# Service Bulletin

Bulletin No.: PIT5224

**Subject:** Updated Left and Right I/P Fuse Block Labeling

**Models:** 2014 Chevrolet Silverado 1500  
2014 GMC Sierra 1500  
Built Prior to July 26, 2013 in Silao (11th Vin Position = G)

3600974

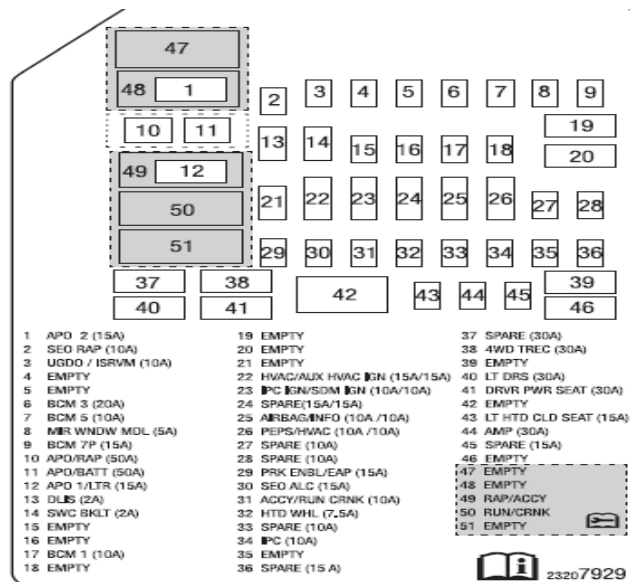
After inspecting the Left and/or Right I/P Fuse Block Labels, it may be noted the numbering is incorrect.

Inspect the lower right corner of each label for P/N 23114670 (Left) and/or P/N 23114671 (Right). If these part numbers are found, replace the label(s) with updated label(s): P/N 23207928 (Left) and P/N 23207929 (Right). See photos below of the updated labels.
